TXDOT AVIATION STATEWIDE AIRPORT ELECTRICAL CONSTRUCTION PROJECT (AVSAE) - GROUP ALPHA
TxDOT CSJ No. 4222AVSAEA

ADDENDUM NO. 3

May 14, 2025

2 / ET4.2 **PROPOSED VAULT PLAN**
SCALE: 1/2" = 1'-0"

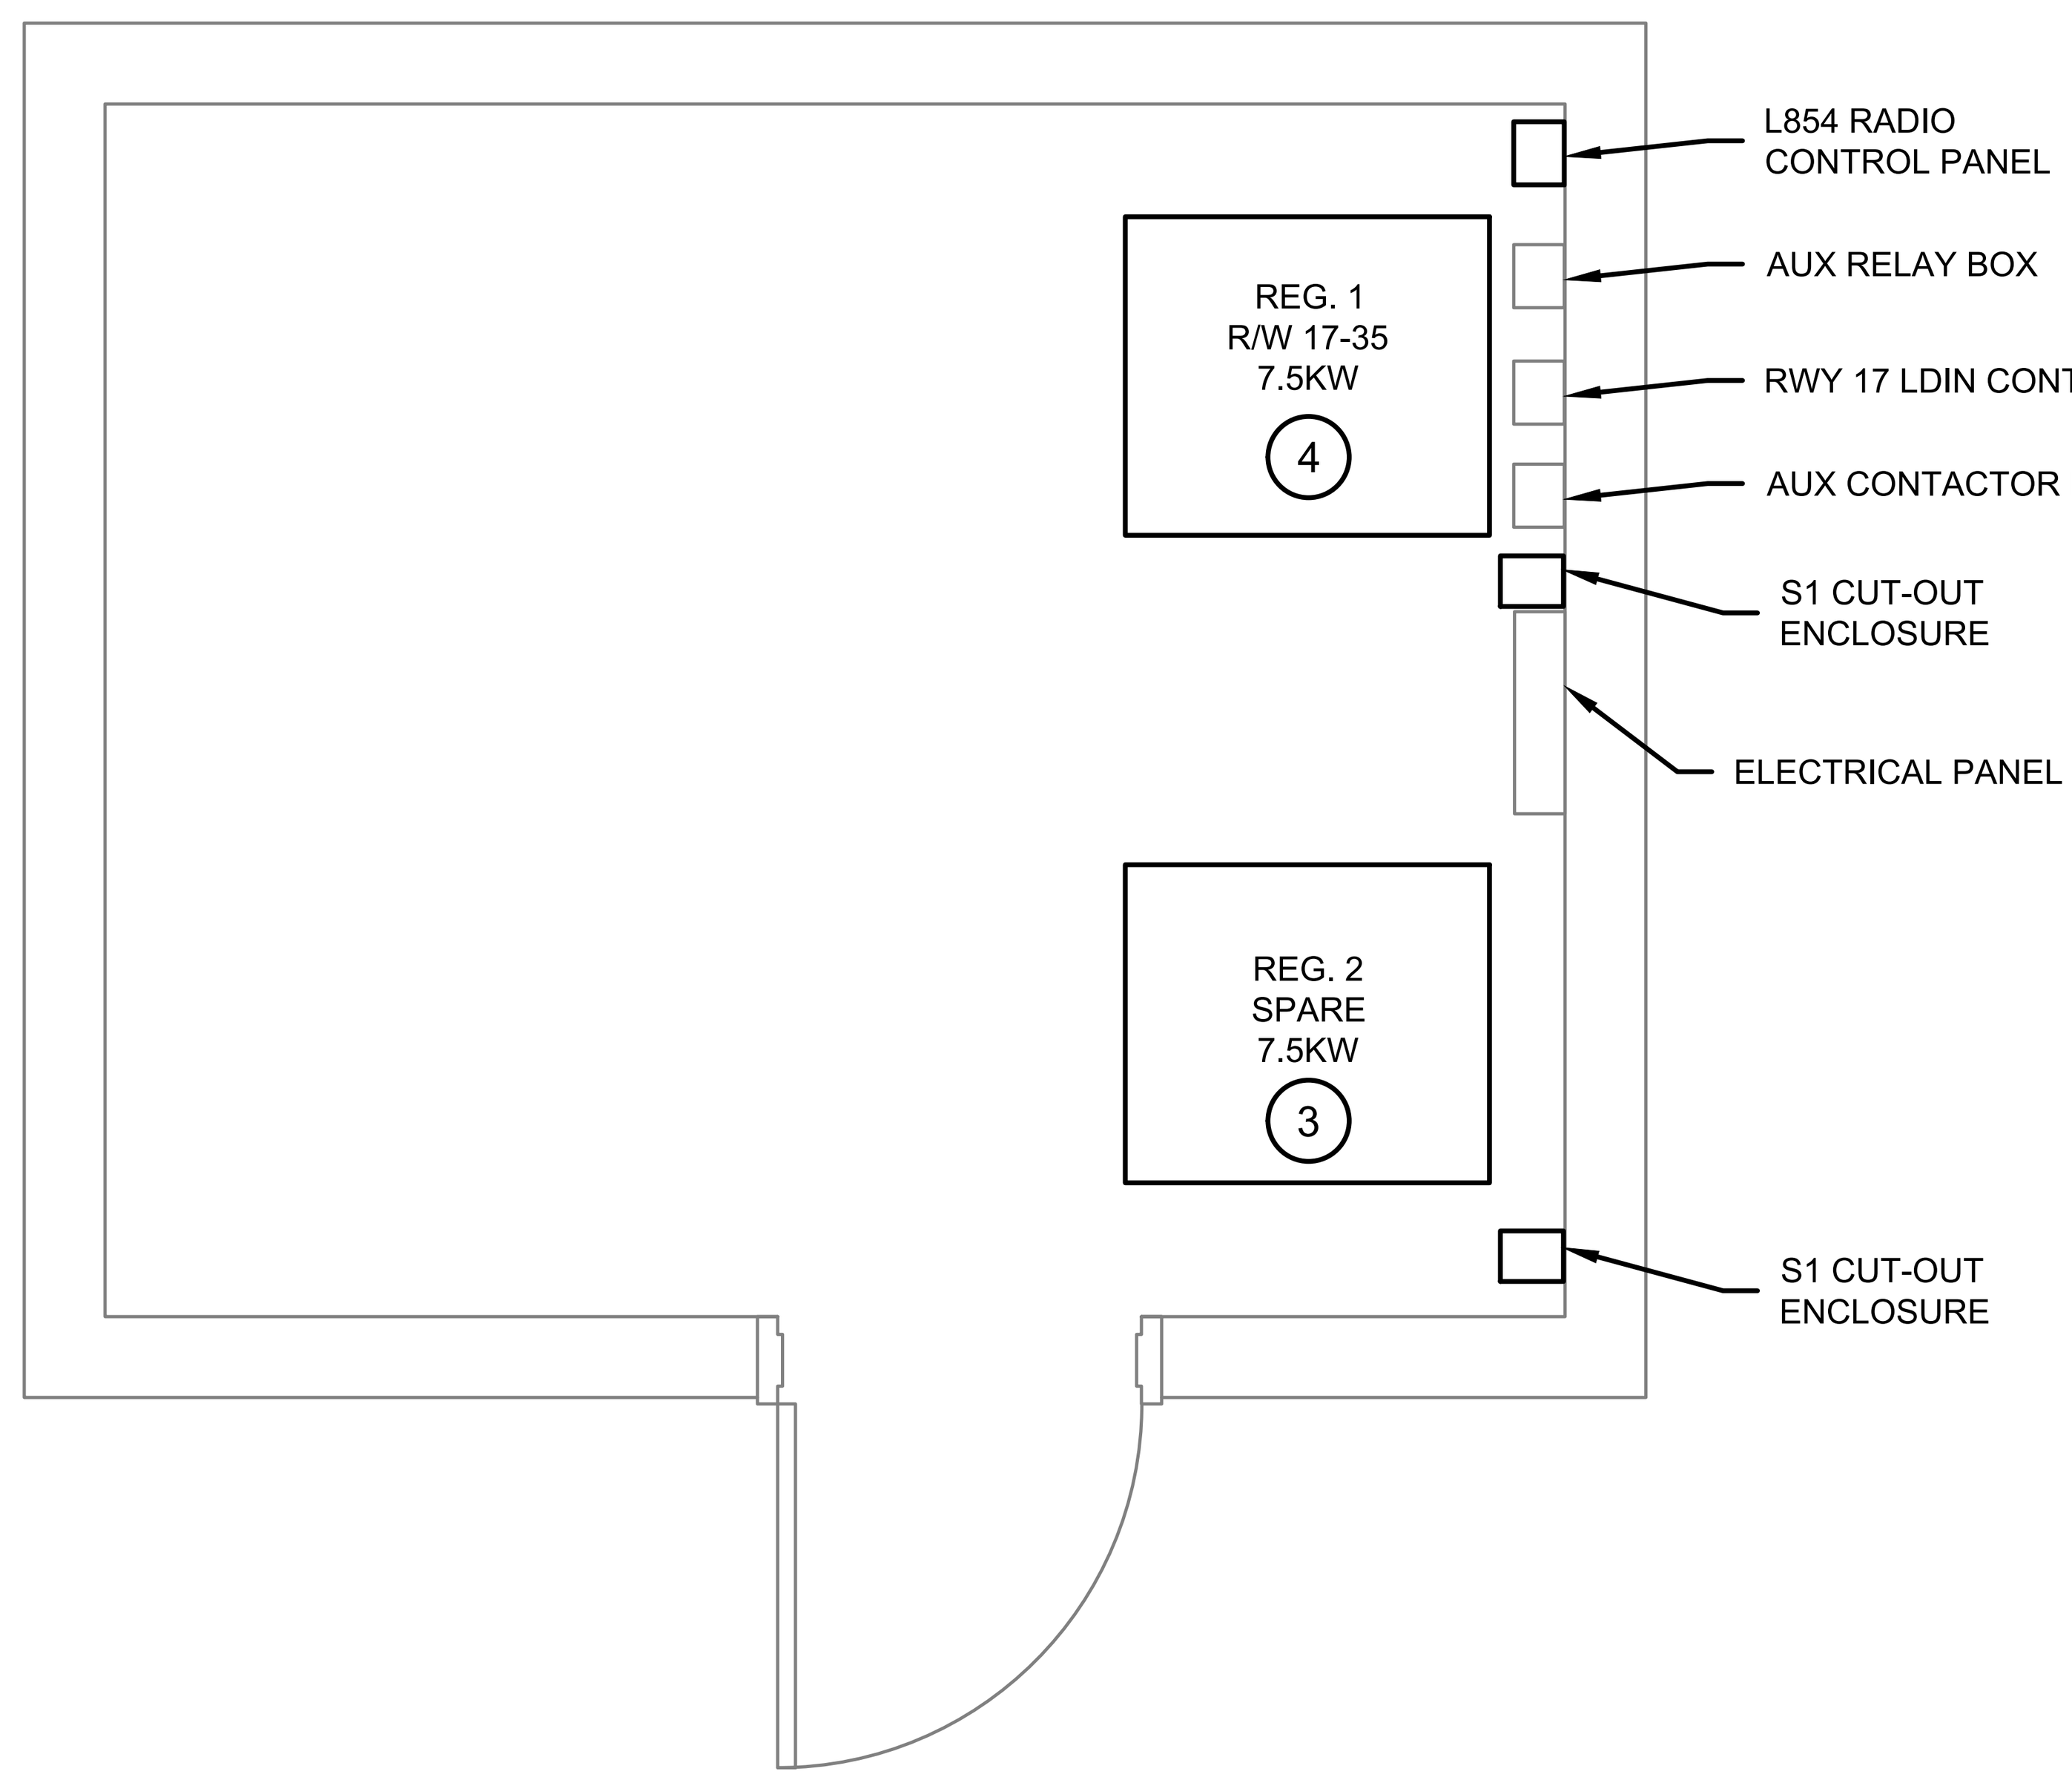
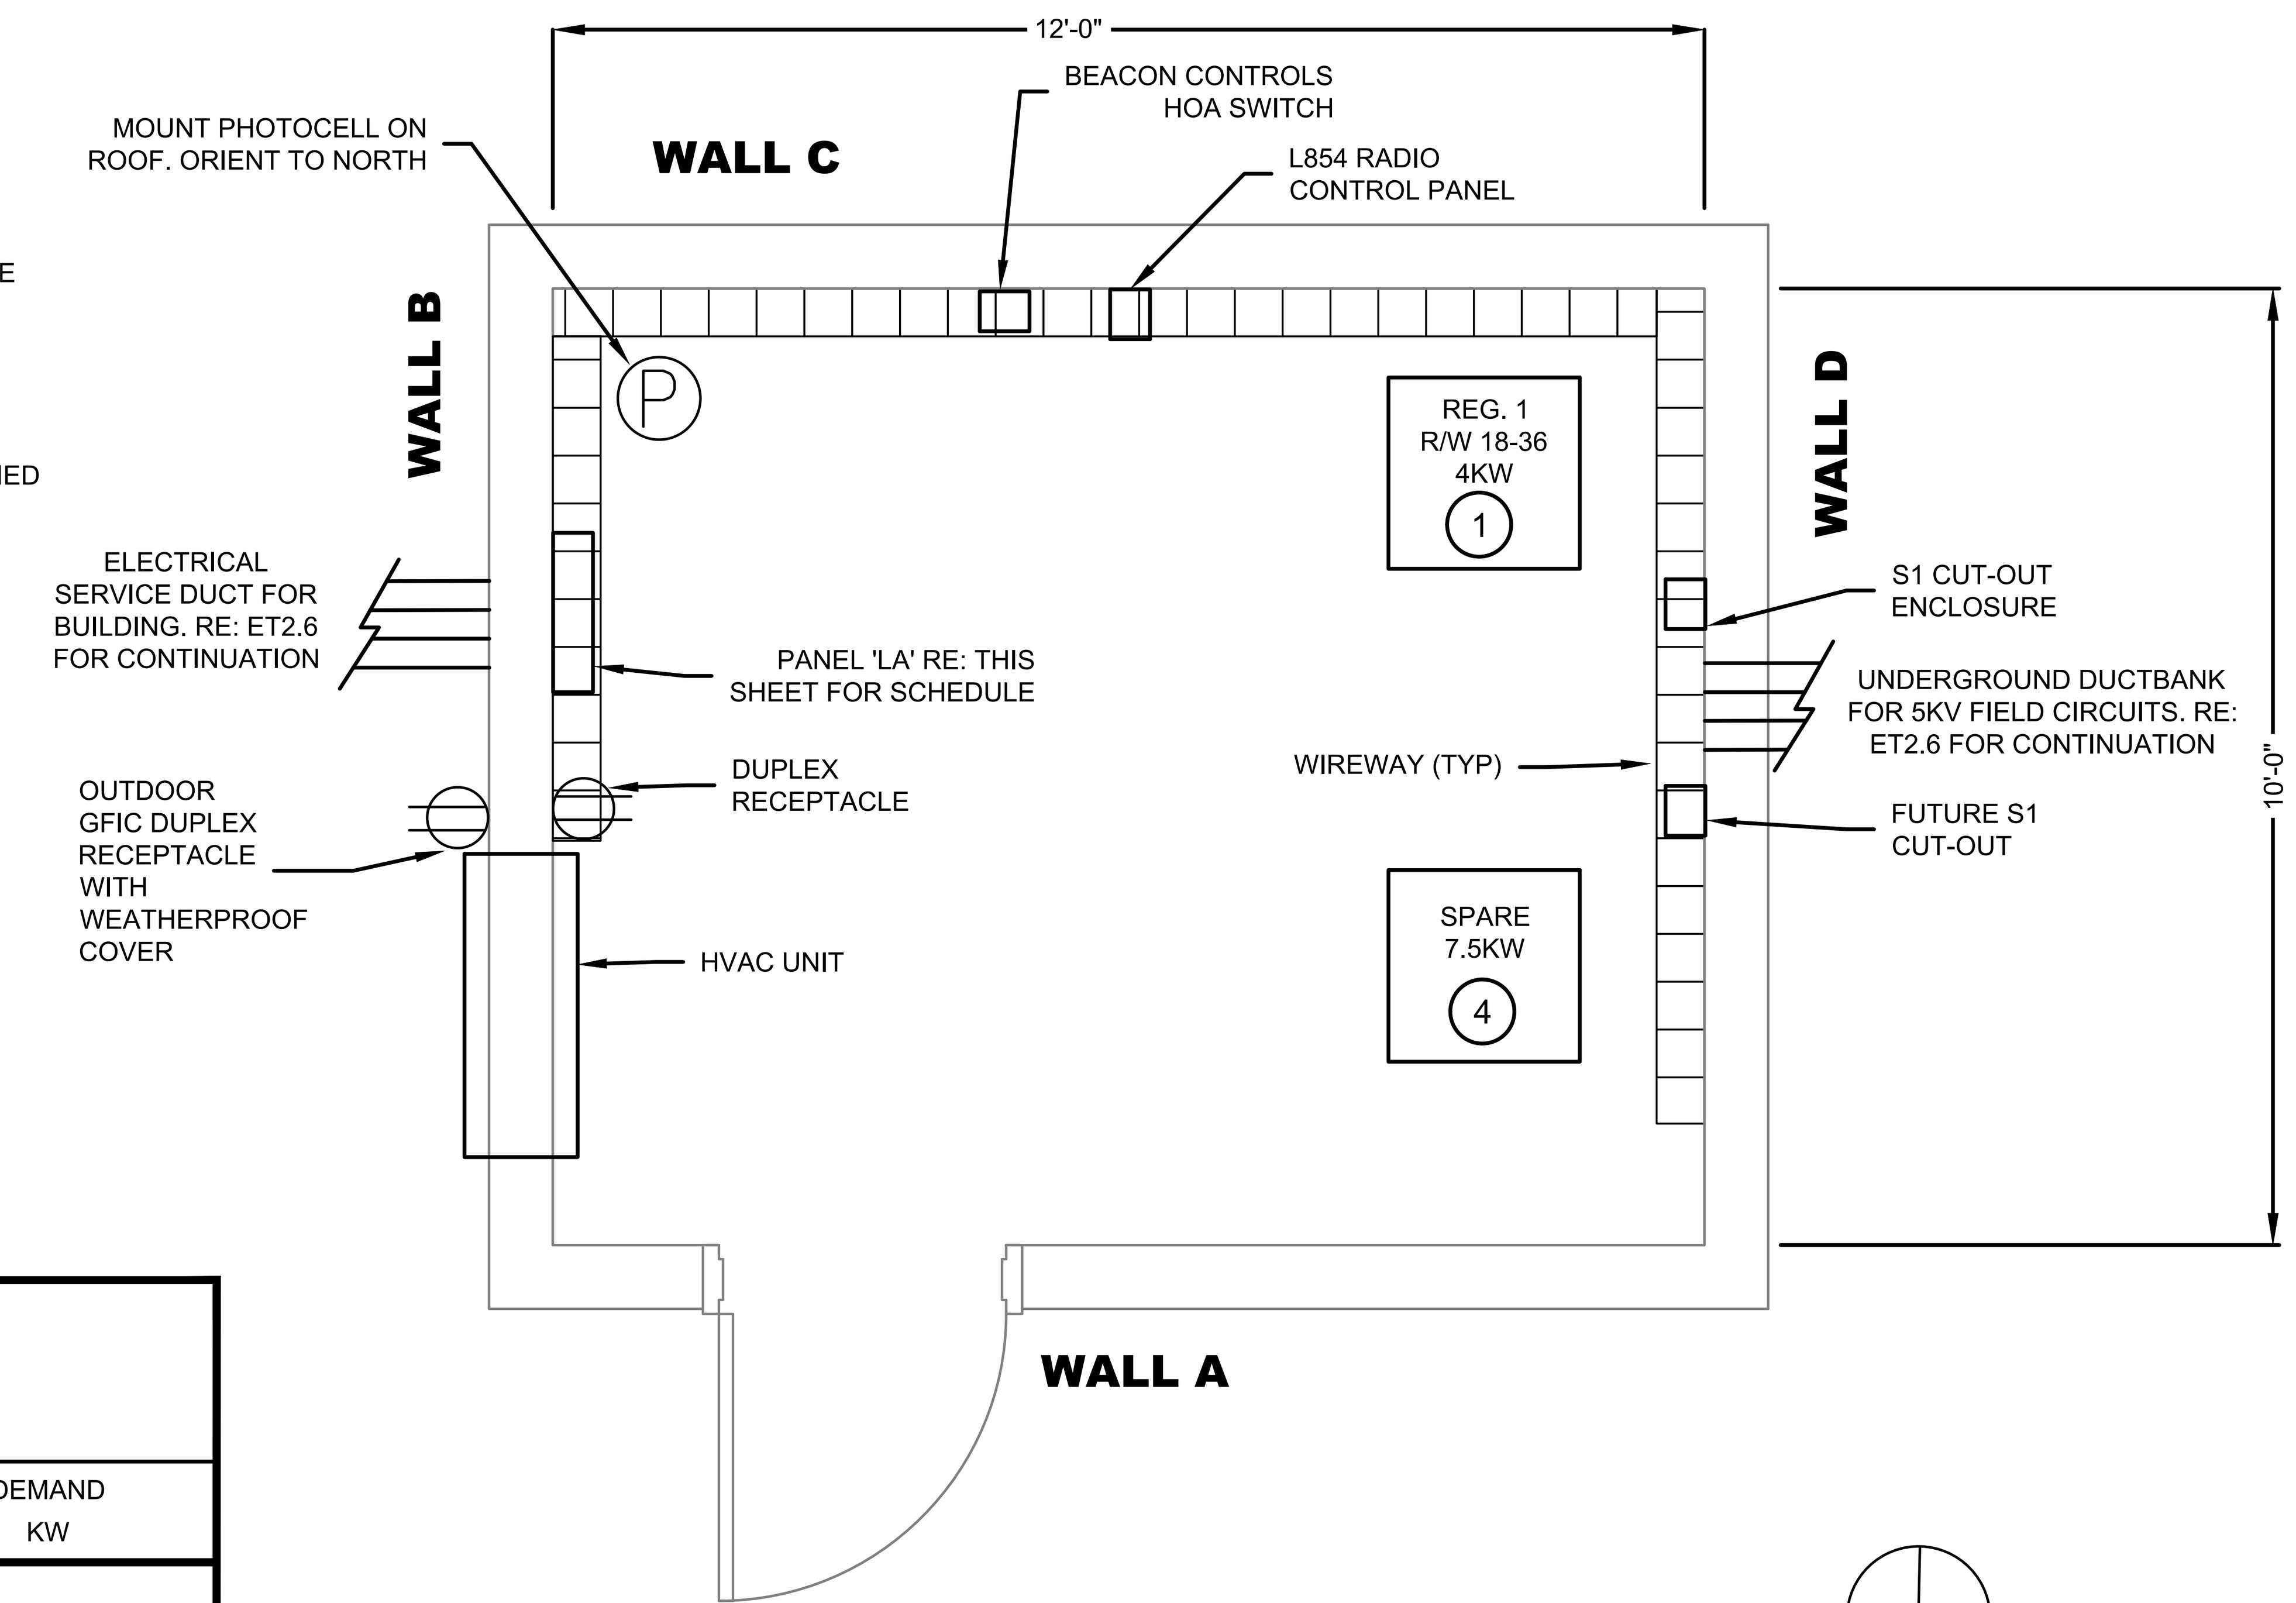
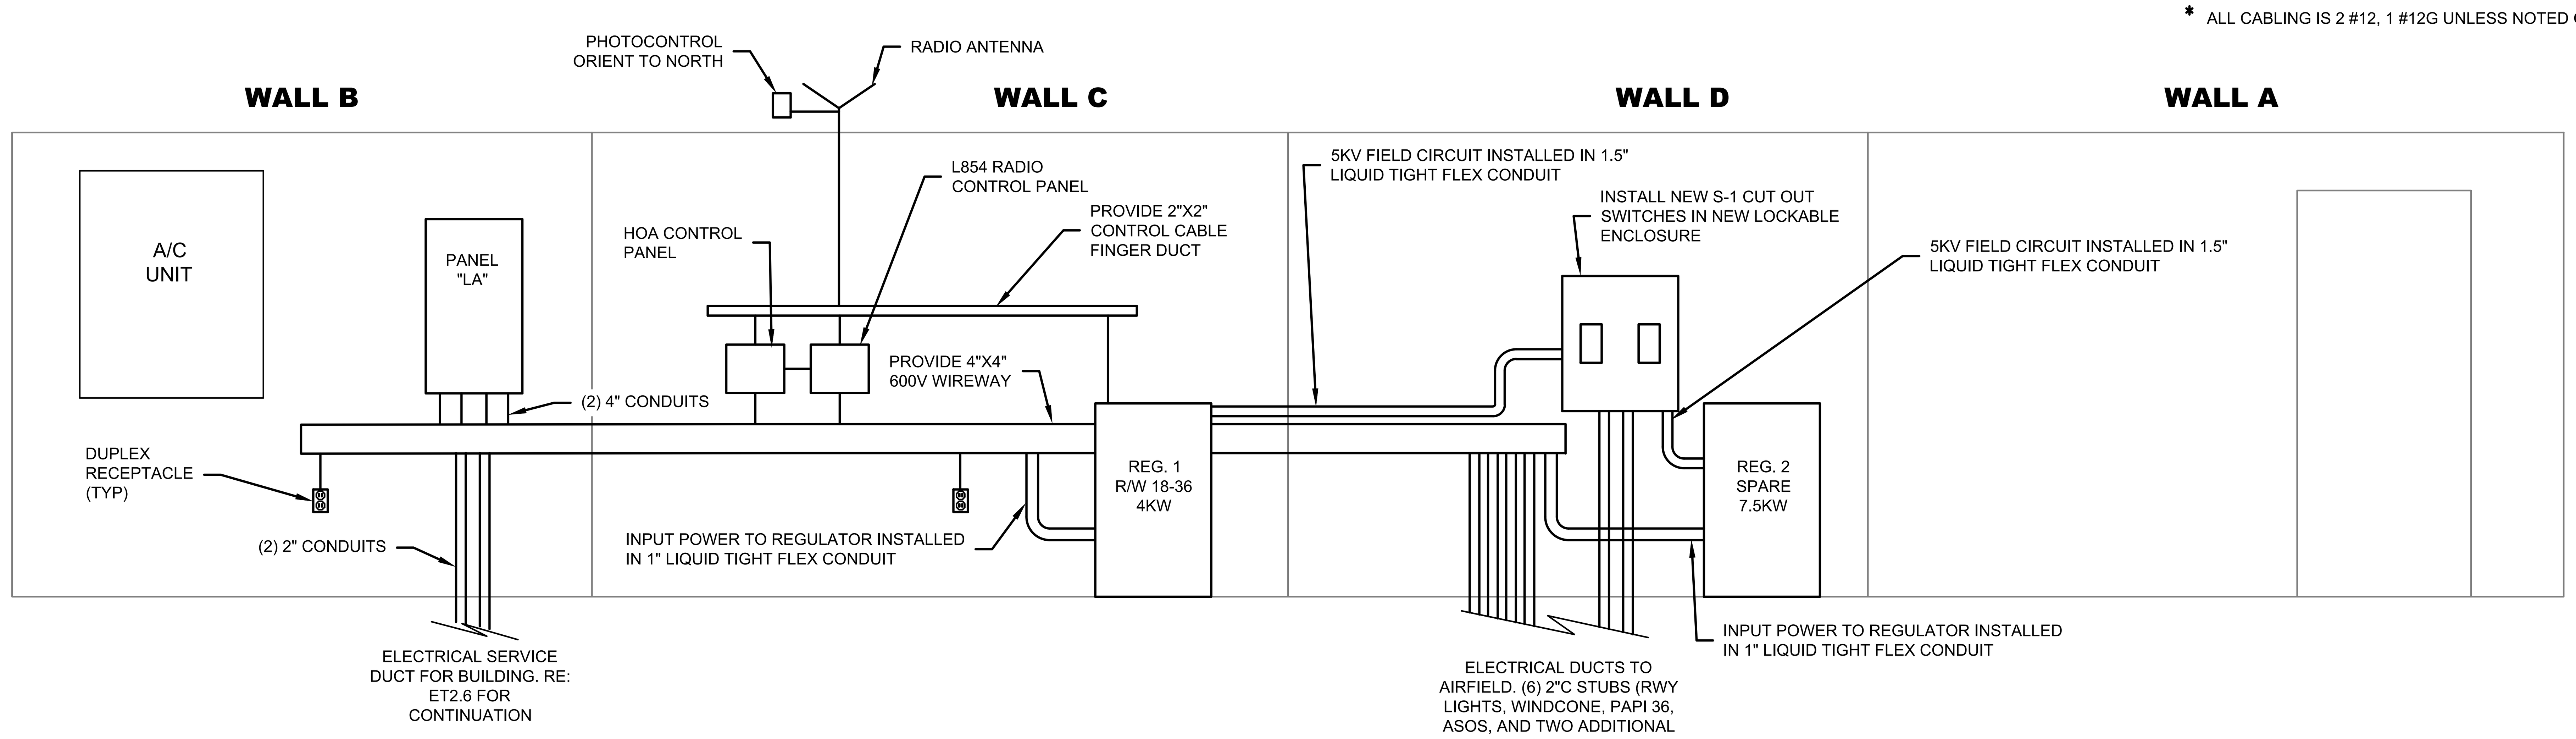
sss) Sheet ET4.2 – Electrical Vault Plan. Revised proposed vault equipment layout for entire sheet.
